**Re: Response to New Mexico Oil Conservation Division Denial Comments
November 2023 Remediation and Pilot Test Summary and Full-Scale Soil Vapor Extraction
System Recommendation Report
Holly Energy Partners – Operating, L.P.
Former Tank 970 / Artesia Station West, Eddy County, New Mexico
NMOCD Incident No. nCE2003752717**

Below are NMOCD’s June 11, 2024, denial comments (shown in *italics*) to the November 2023 Recommendation Report and HEP’s responses to NMOCD’s denial comments.

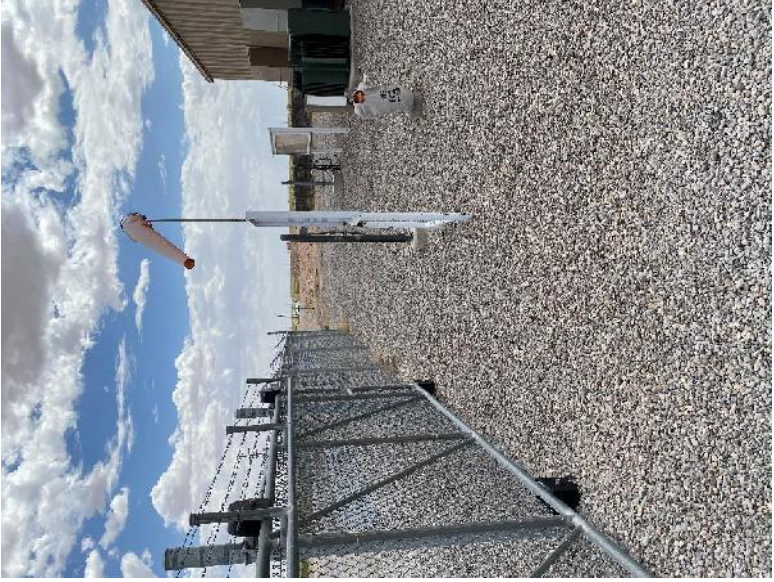
- West – In accordance with NMOCD's request during the August 2024 virtual meeting, a "deep" boring is proposed west of the former Tank 970 berm along the western Site boundary. The boring will be drilled to a depth of approximately 102 feet bgs to provide lateral delineation of hydrocarbon concentrations to Reclamation Standards in the upper 4 feet and to Closure Criteria below 4 feet bgs.
- North – A shallow hand auger boring is proposed at the northern Site boundary. The boring will be advanced to a depth of 4 feet bgs to provide lateral delineation of hydrocarbon concentrations to Reclamation Standards in the upper 4 feet at boring SB-North. Additional lateral delineation of hydrocarbons to Closure Criteria in soil below 4 feet bgs at the northern Site boundary is not needed, as the existing soil sample results below 4 feet bgs at boring SB-North do not exceed the Closure Criteria.

As discussed above, HEP proposes to advance two additional borings to better delineate hydrocarbons in soil west and north of the release area. A "deep" boring is proposed along the western Site boundary (i.e., west of the former Tank 970 berm). The boring will be drilled to a depth of approximately 102 feet bgs using an air rotary drill rig to provide delineation of hydrocarbon concentrations to Reclamation Standards in the upper 4 feet and to Closure Criteria below 4 feet bgs. The proposed boring location (SB-West) is presented in **Figure 1** and is proposed west of the Site fence line based on consideration of the access needed for the air
